T Design Sweaters Ltd.(11247)

Jarun, Konabari, Gazipur
(+23.999426N, 90.325706E)
24.AUGUST.2014

Identified Priority 1 Concerns

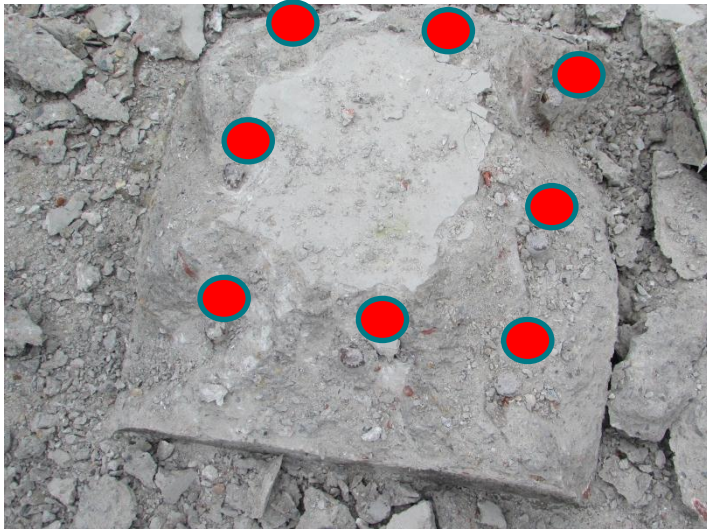
There were no details of the strengthening work (column jacketing) available to review. There appeared to be some confusing aspects; the original column was a stone aggregate concrete column, the jacketing used brick chip aggregate. The jacketed columns need to be checked for full BNBC code compliance as part of a DEA.

The structural capacity of the columns needs to be carefully assessed based on the exact as-built detailed drawings.

We were informed that column strengthening work has been done. No drawings were provided. The original as-built drawing shows 16 bars in a typical C3 column. On site we found 8 bars in an outer perimeter. A portion of column was further broken down and a further 8 bars were found in an inner perimeter.

There were no drawings for the column strengthening work and the rebar arrangement doesn't match the original as-built drawings.

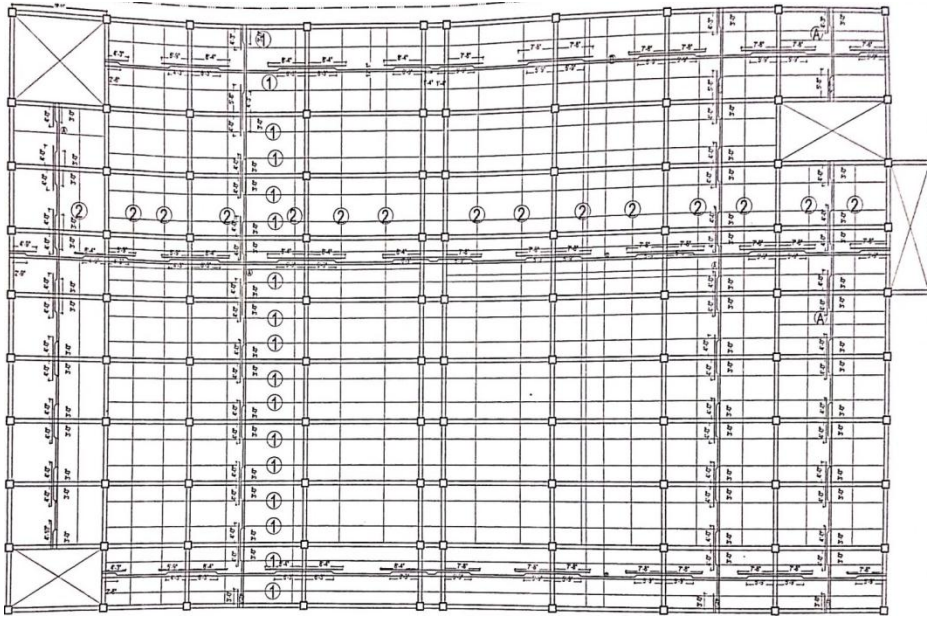
Cracks on beams need to be investigated to determine the cause of the cracking.

The structural capacity of this floor also needs to be assessed.

12	4th Priority 3 - Cracks on beams need to be investigated to determine the cause of the cracking.	Repair and strengthen the slabs locally as necessary.	6-months
